**Planning Commission Meeting Agenda
City of Prairie Village
7700 Mission Road
Council Chambers
Tuesday, May 5, 2026
6:00 PM**

STAFF REPORT

Application: PC 26-01 & 26-11

Request: Rezoning from R-1A to RP-1B and Final Plat

SHEET
C1.0

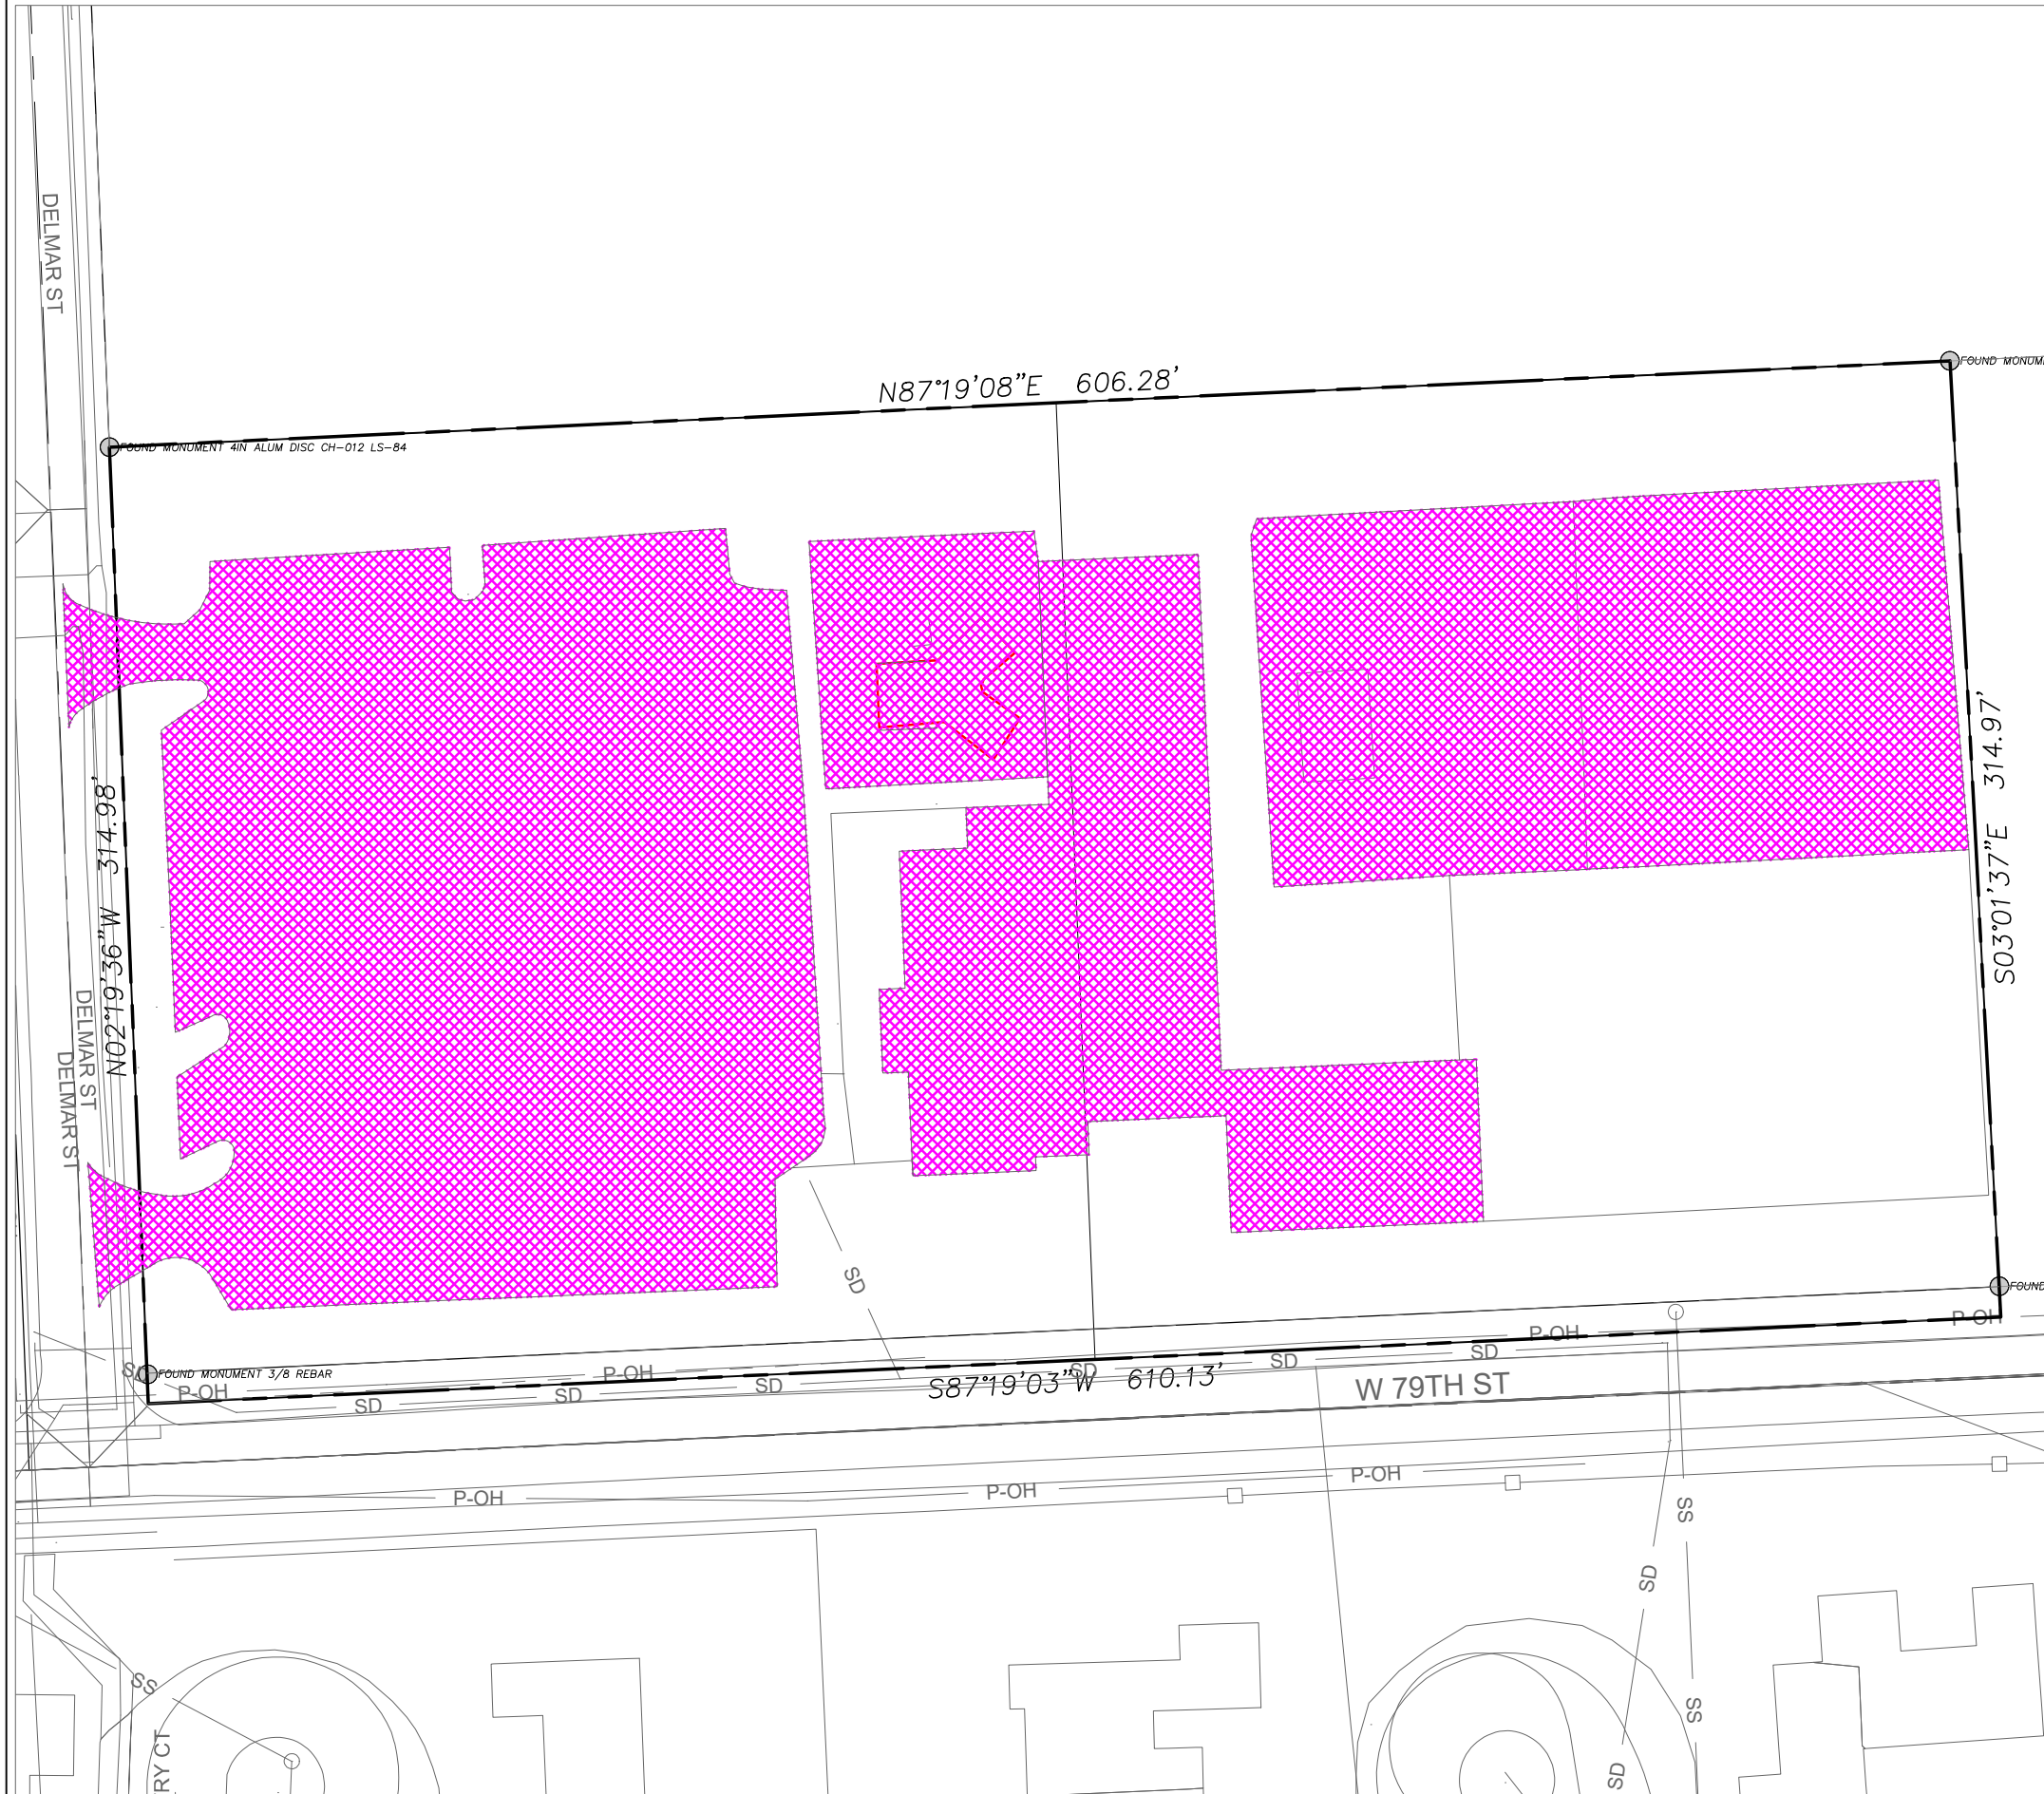
6. Provide a narrative describing how impervious areas for each lot will be controlled during design and construction to ensure consistency with the assumptions used in this study. Sheet C1.0 includes a table of impervious areas by lot; clarify whether each lot will be required to conform to the values shown.

EXISTING PREVIOUS AREA	REV. NO.	DATE	DESCRIPTION	BY
79TH AND DELMAR YMCA DEVELOPMENT				
SPRABIE VILLAGE KS	2026

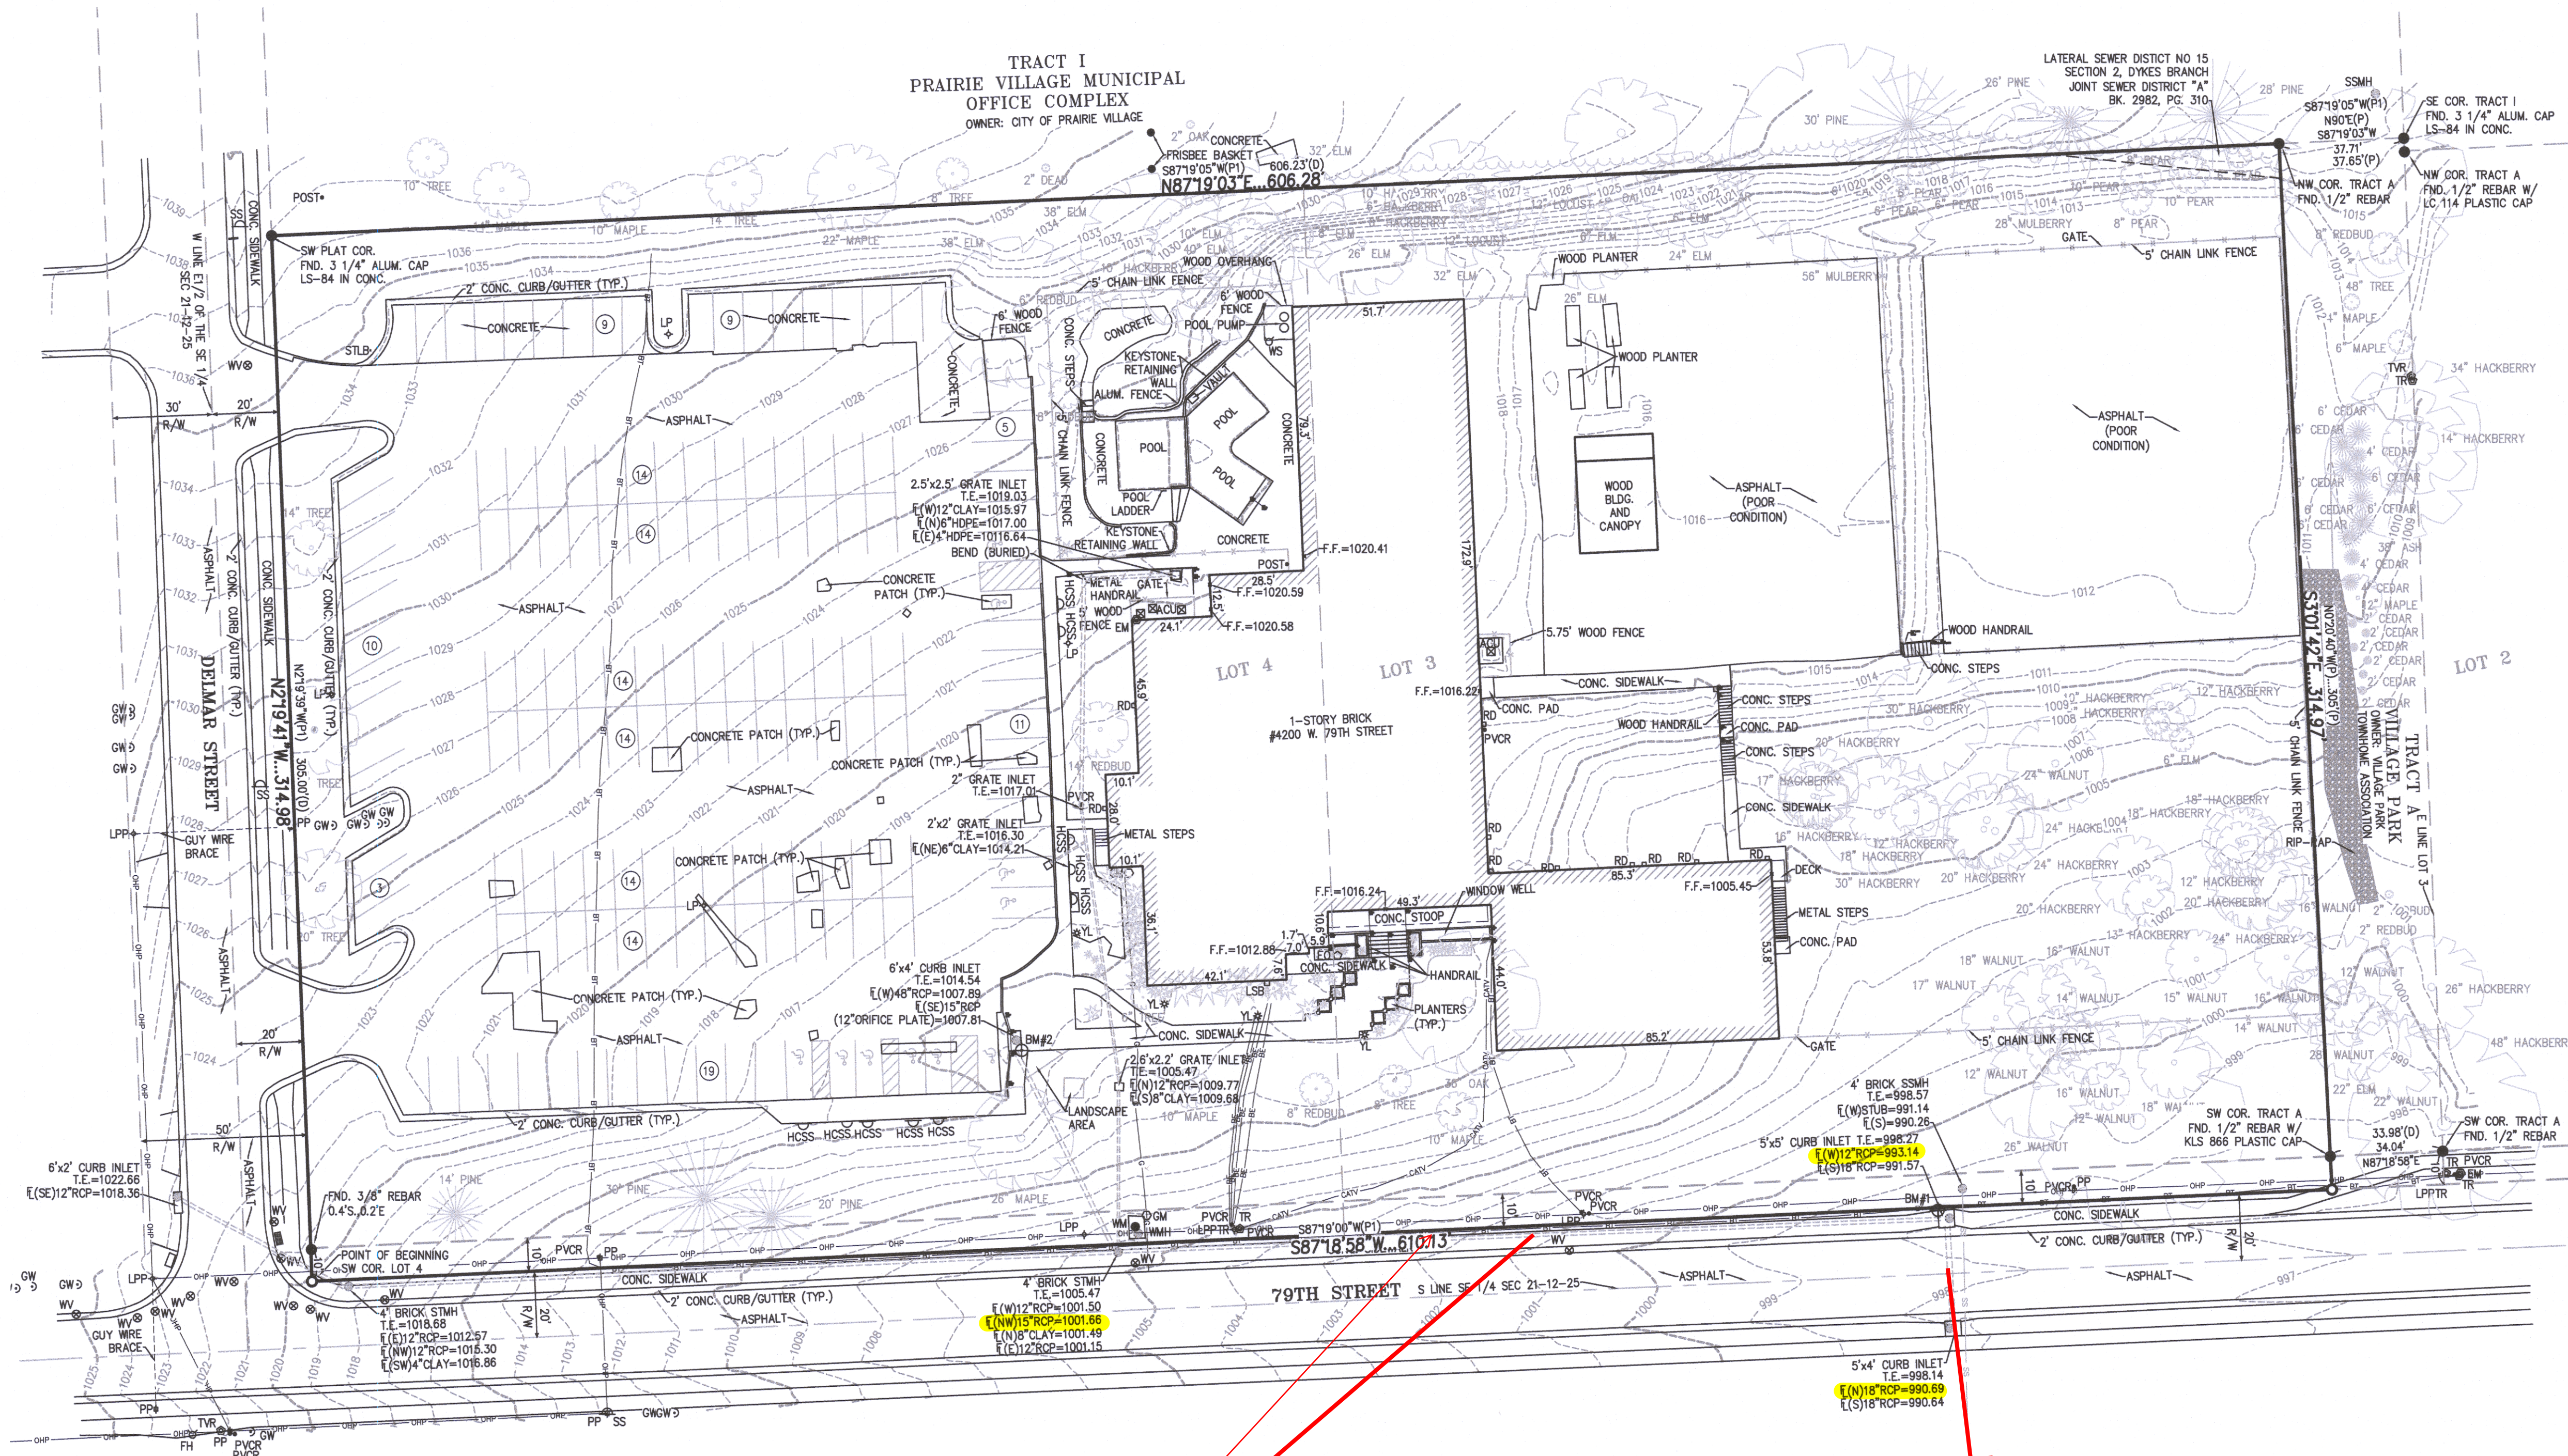
7. On Exhibit 1 and the Proposed Impervious Area Exhibit, the hatching is labeled as “Pervious” where it should be “Impervious.” Please correct the labeling.

Provide additional information on methodology for this comparison. Evaluation should determine if system is pressure flow vs gravity flow. Peak flow at 79th can't be increased with this development. Summary of surcharge flows should be provided.

DRAWING PLAN		REV. NO.	DATE	DESCRIPTION
REZONING PLAN 79TH & DELMAR				
PRAIRIE VILLAGE, KS		2026	REVISIONS	
drawn by: _____		BE		
designed by: _____		LM		
project no.: _____		02-06-2026		
date: _____		02-06-2026		
SHEET C3.0

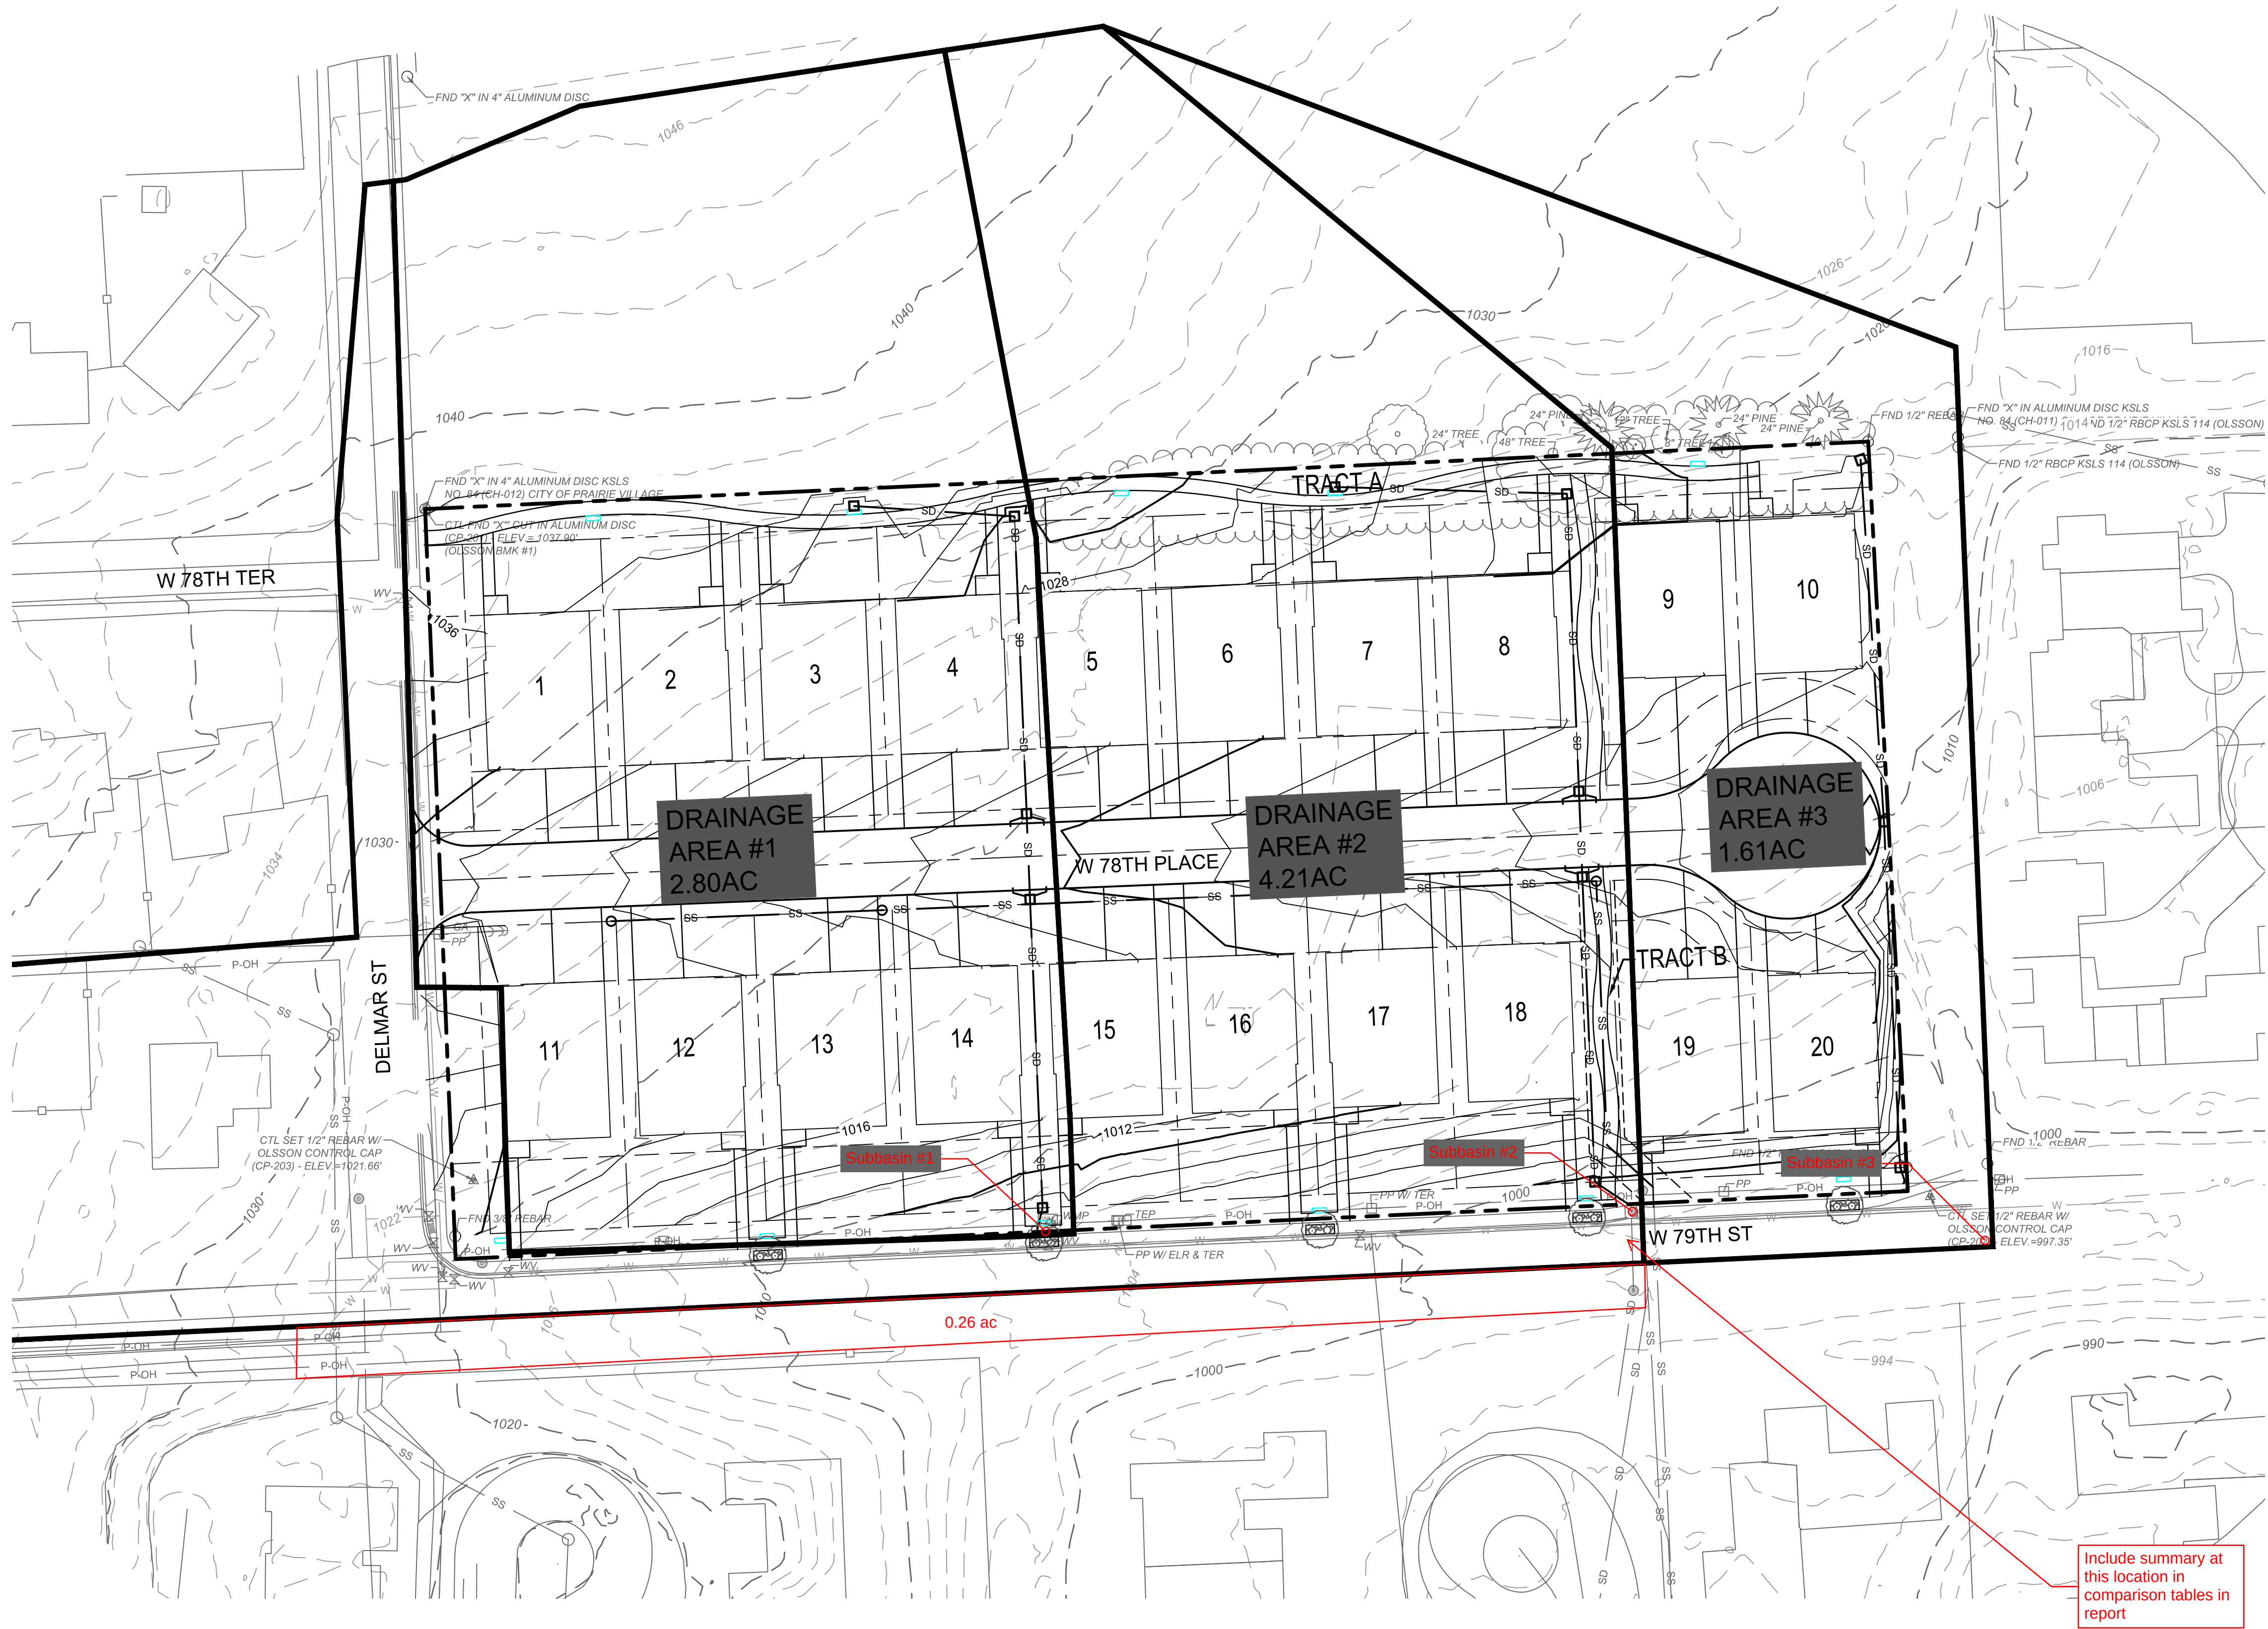
5. Sheet 3 indicates surcharge and bypass conditions at the inlet along 79th Street. Provide calculated flow rates for both surcharge and bypass conditions, along with supporting
